# **CITY OF MACKINAC ISLAND**

### **PLANNING COMMISSION**

**Tuesday, September 09, 2025 at 4:00 PM**

[b.](#) MD25-069-054(H) Doud Change of Use & Alteration Home to Hotel

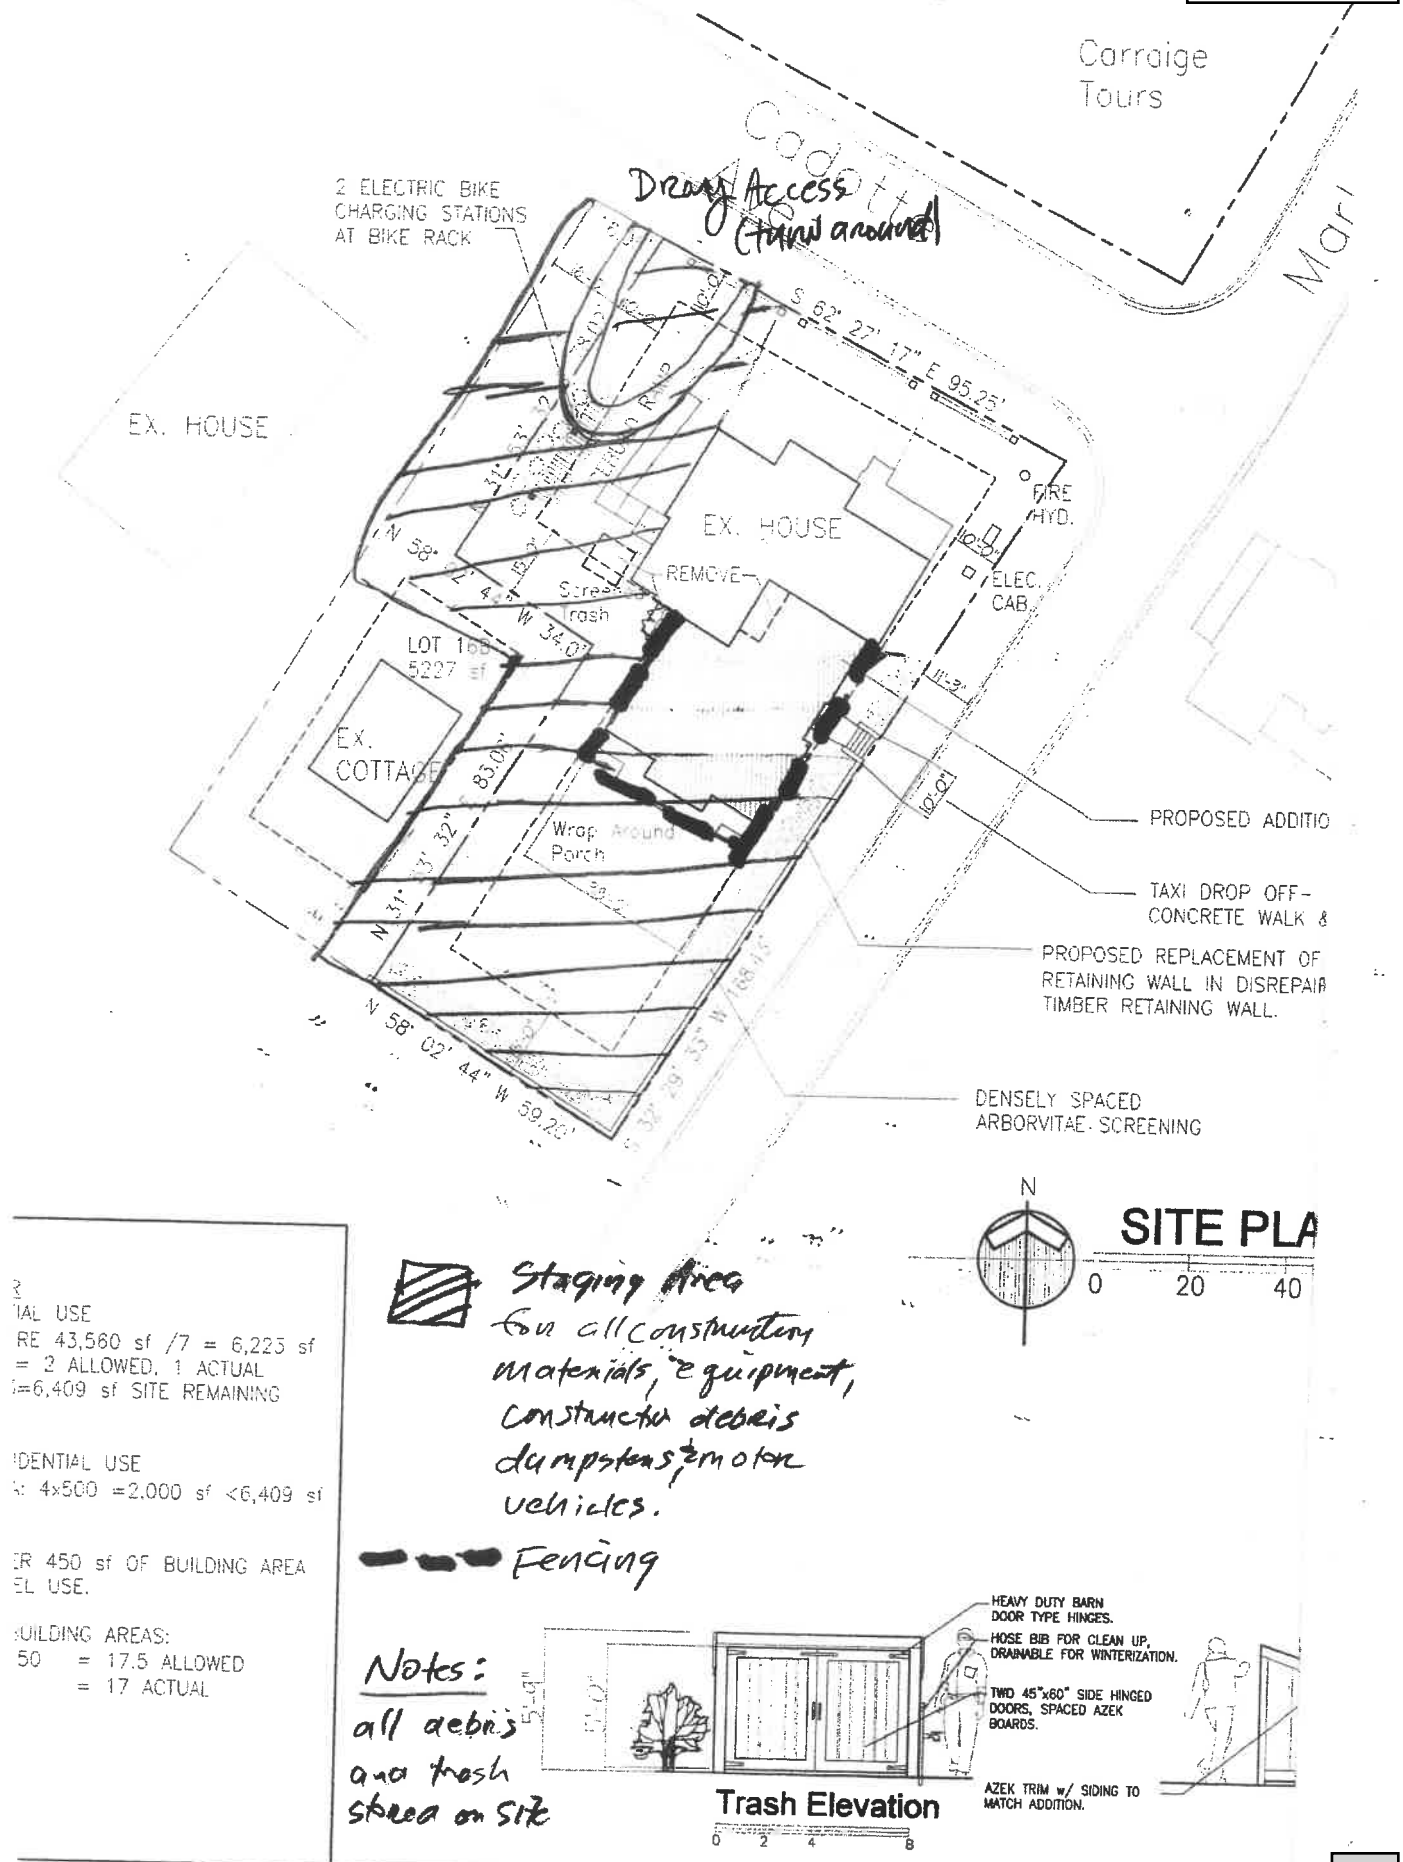
**Look in to the encroachment on the right of way.**

I am presenting this to the city next Wednesday

# Construction Staging Plan

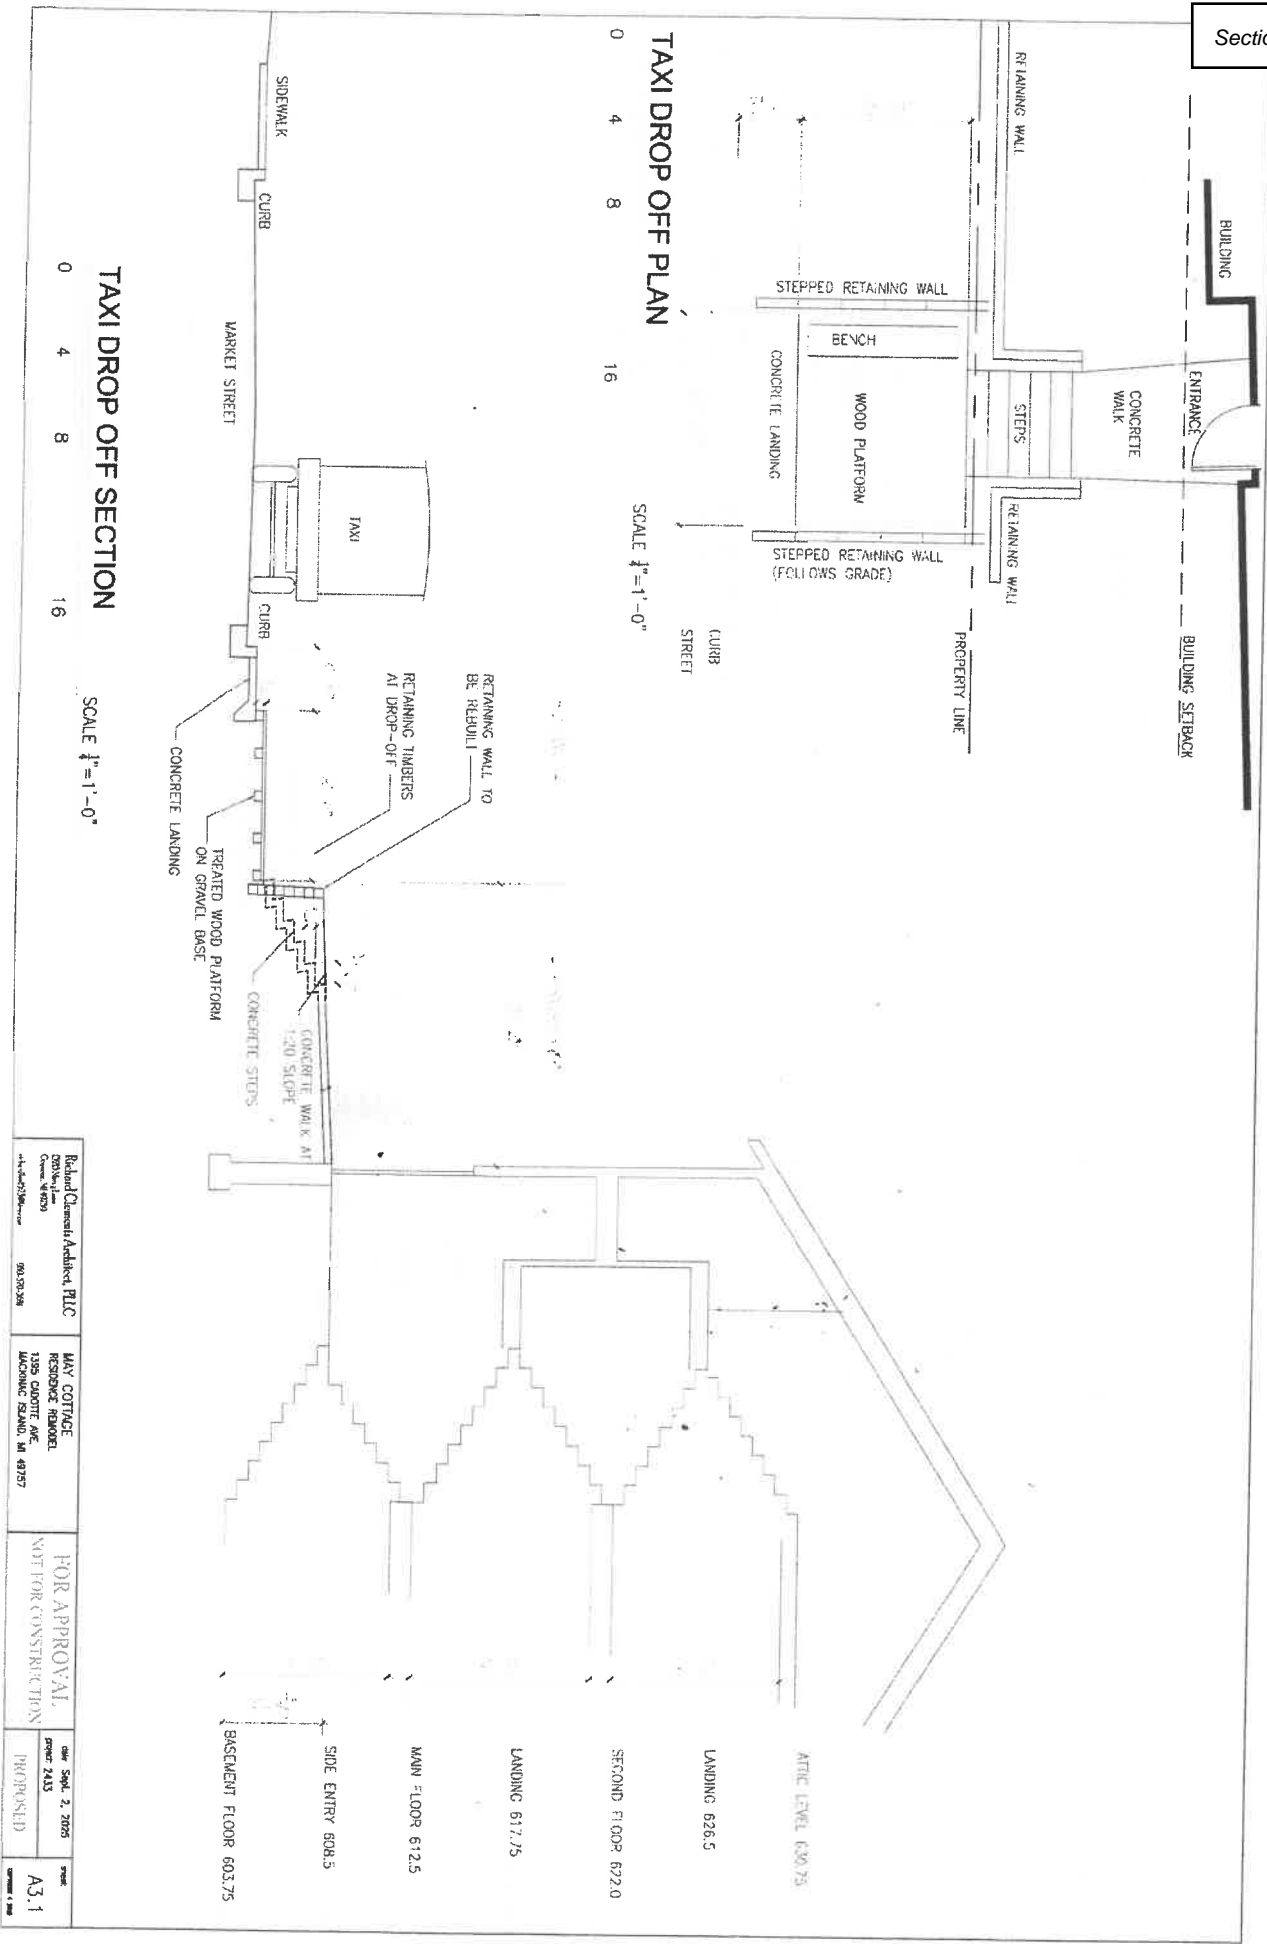
**3. Provide the written construction criteria on the Site Plan Checklist.**

- (a) See attached construction staging plan. This plan supplements the August 26, 2025, submittal and also contains an approval letter from Mrs. May.

I'm writing this letter to inform both Council and the Planning Commission that Andrew Doud is allowed to make full use of my yard during his project. This includes storage, staging and dray delivery.

rev: for:  
date: July 24, 2025 sheet:  
project: 2433  
SITE PLAN A1.0  
COPYRIGHT © 2025

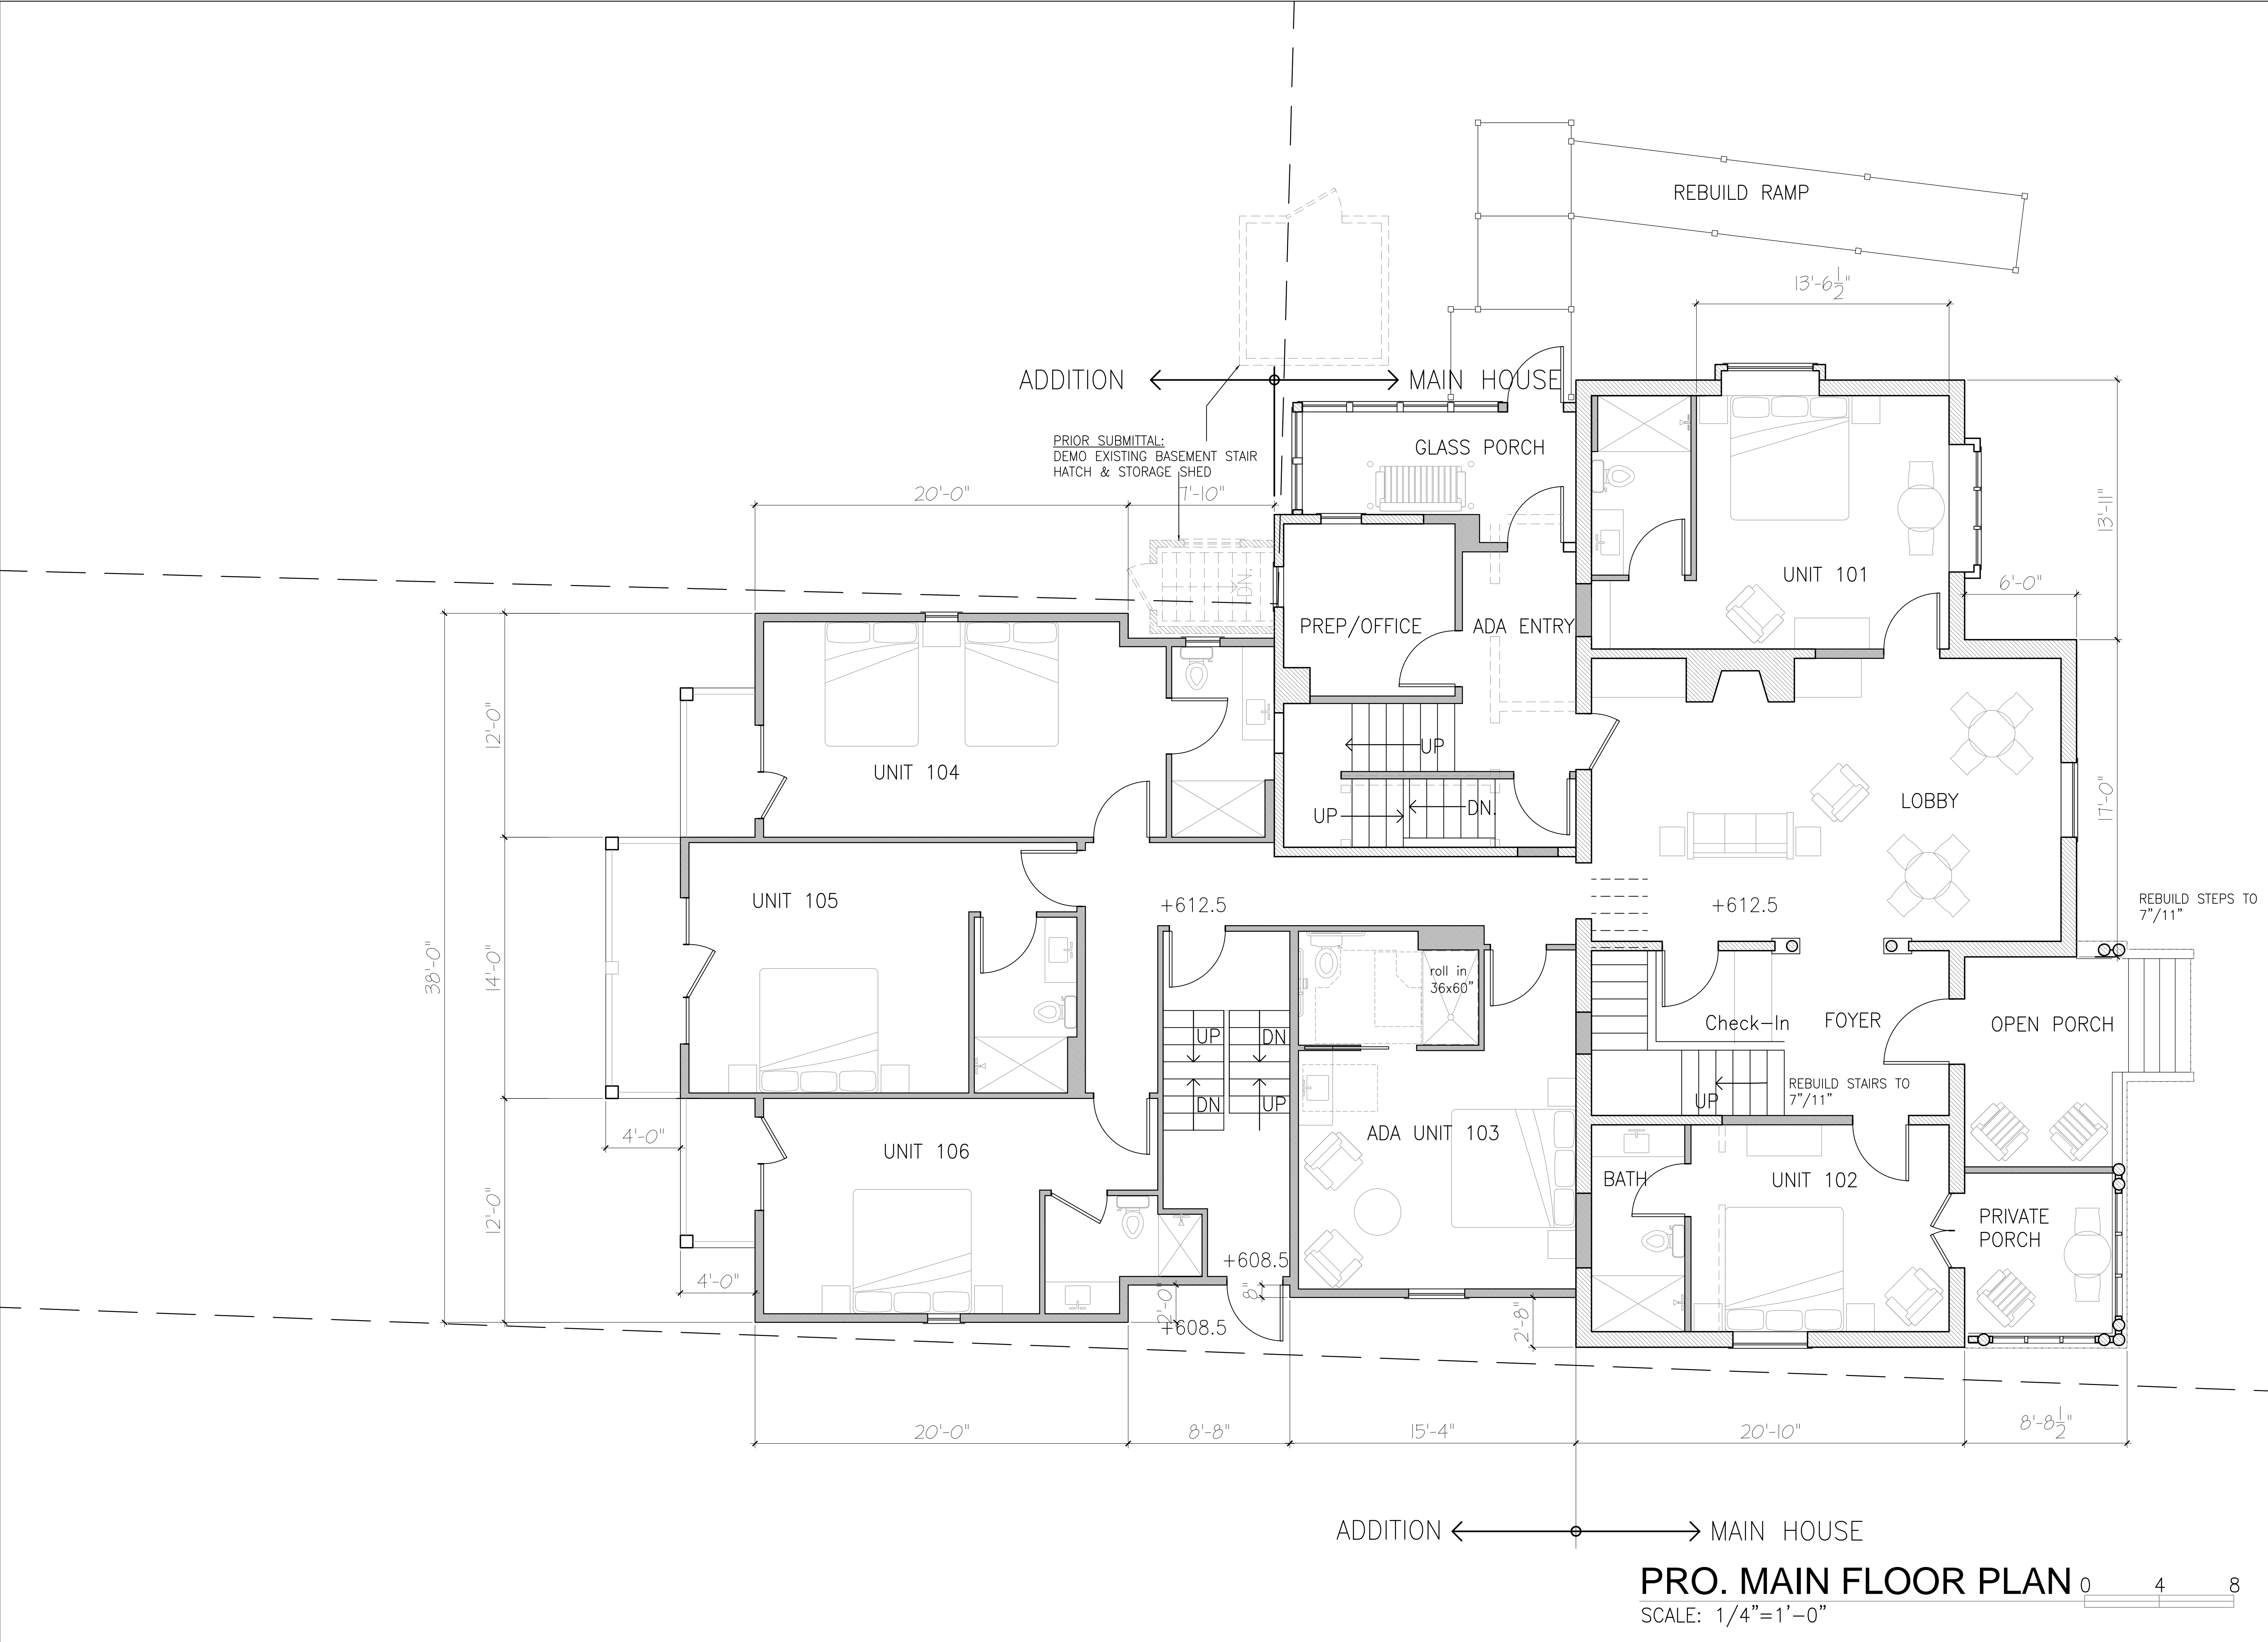
### **Provide Landscape plan for the area between the Hotel and the House.**

**2. Provide a landscape plan for the area between the proposed hotel and the residential structure next door.**

I have submitted a new site plan with a tree barrier between the properties

1. Landscape Plan. Shows landscape plan for area between hotel and adjacent residence. Also shows electric bike charging station, bike racks, trash plan, lighting and stormwater plan.
2. August 26, 2025 reply letter.
3. Construction Staging Plan. Depicts staging area for all construction, fencing, and dray access.
4. Mrs. May approval letter.
5. Taxi Drop-Off Plan. Plan I submitted to City Council which received positive comments regarding the traffic issue.
